Overview: Production error in version 1.0 harnesses; The immobilizer wire (orange/black) is in pin position #4 instead of pin position #5. Although an effort to correct the issue was made, some quantity of harnesses did get shipped before the issue was spotted. We are advising to inspect the harness BLADE connector before attempting to install harness or program the module. This issue is not known to affect the version 2 harnesses, which require no modification.

Descripción general: Las primeras versiones del arnés FTI-STP1 requieren modificaciones para aplicaciones de transmisión automática (AT), algunas del producto se pudo modificar antes del lanzamiento, pero una pequeña cantidad se lanzó sin modificaciones.

FTI-STP1: Notas de preparación y cobertura del vehículo

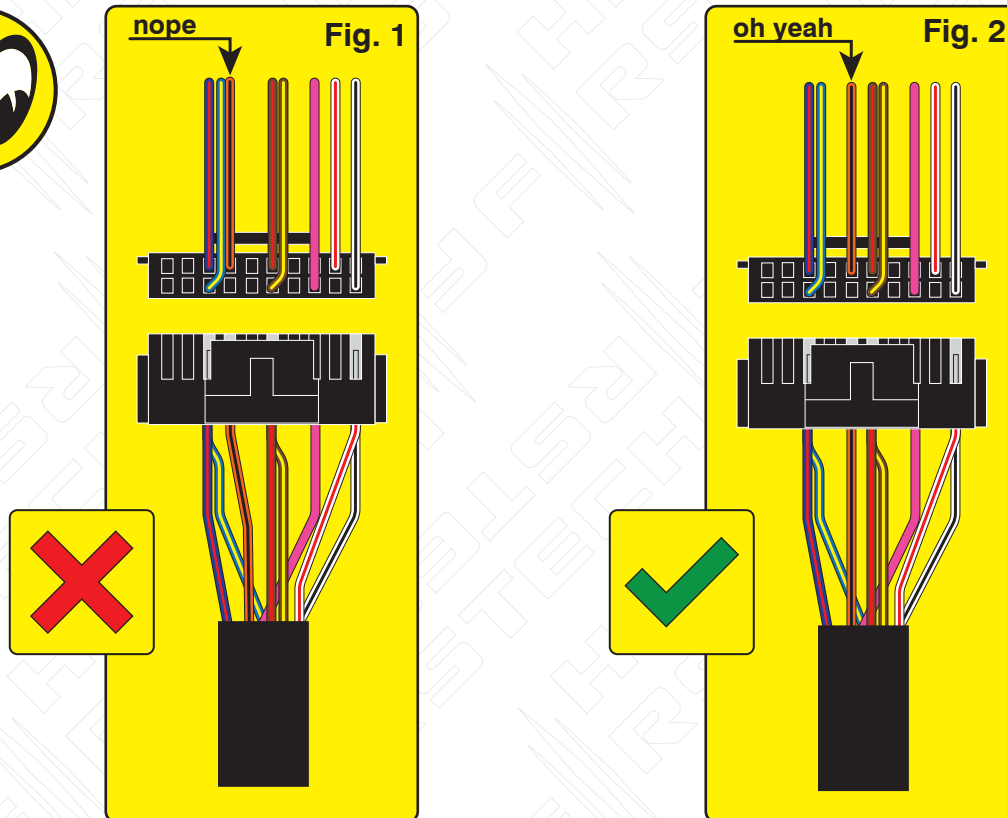
Issue: Module fails to program correctly to vehicle, does not allow the vehicle to be remote started.

Correction: Step 1.) Locate the orange/black wire and confirm whether it is positioned as illustrated in Fig. 1 or Fig. 2. If the wire is as illustrated in Fig.1, proceed with Step 2 through 5 and complete the repair procedure outlined, if the wire is as illustrated in Fig. 2, correction is not necessary, proceed with harness installation and module programming.

Step 2.) Using a pick, lightly depress the catch that secures the terminal in the housing then remove the wire and terminal from the housing.

Step 3.) Using a fine tip razor or utility knife, insert the blade beneath the terminal catch and raise it slightly, so that it can be reused to secure the terminal when reinserted into the BLADE connector housing.

Step 4.) Refer to Fig. 2 for correct position of the orange/black wire (next to brown/red) then reinsert the terminal, pressing lightly until the catch 'snaps' into place, securing the terminal in the connector housing.

Step 5.) The repair is complete, proceed with installation and programming.

MODIFICACIÓN REQUERIDA PARA APLICACIONES A/T, SÓLO CON ARNÉS v 1.0

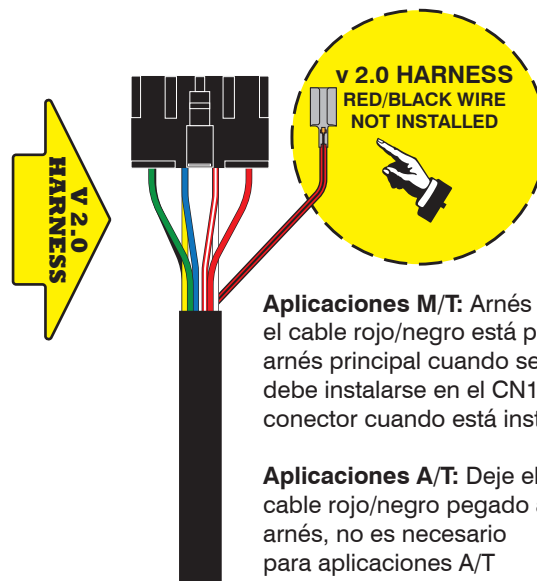
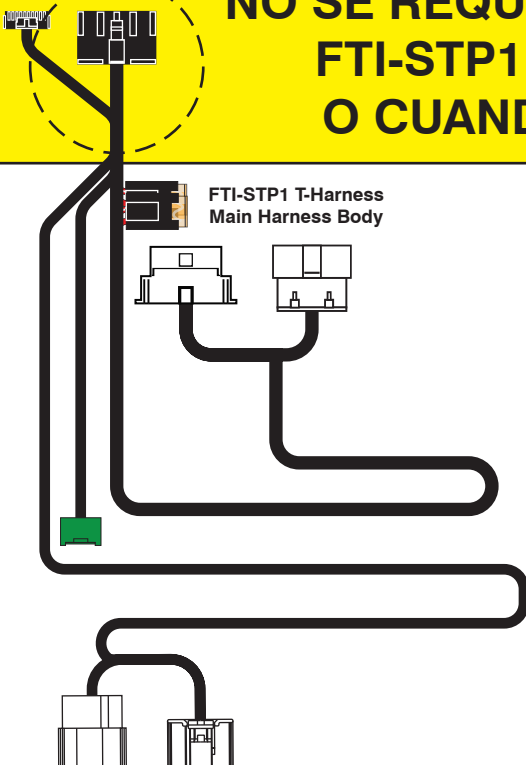
Problema: El arnés en T FTI-STP1 ha sido diseñado para ser compatible con A/T (transmisión automática) y M/T (manual transmisión), pero debido a un descuido en las primeras ejecuciones de producción, la selección se estableció por defecto en el modo M/T.

El uso de un arnés configurado para una aplicación M/T, en un vehículo equipado con A/T, podría provocar daños en el módulo del vehículo, se recomienda que el arnés vuelva al modo A/T antes de la instalación en vehículos equipados con transmisión automática.

Corrección: Localice el cable rojo/negro (+ embrague) proporcionado en el conector CN1 del conjunto del arnés principal. Corte el cable rojo/negro, ya sea al ras del conector CN1 o dejando suficiente cable expuesto para que pueda aislar y asegure los extremos del cable que quedan después del corte. Aísle cada uno de los extremos restantes del cable rojo/negro y asegúrelos para evitar cualquier posibilidad de cortocircuito. Si el cable rojo/negro ya ha sido desconectado, ninguna modificación adicional se requiere para aplicaciones A/T
